Recall Campaign 14V-648: Check Driver's Side Door Mirror and Replace If Needed

F25 (X3)

F26 (X4)

Produced from July 28, 2014 to August 26, 2014

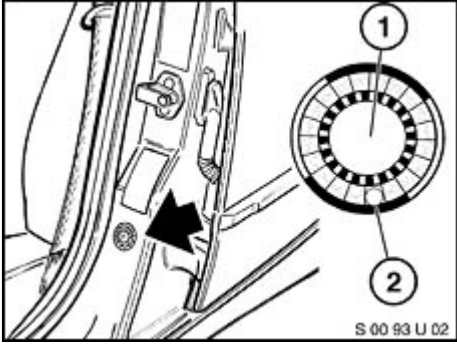
There is a potential risk that a incorrect driver's side door mirror was installed.

Incorrect door mirror

Replace the driver's door mirror.
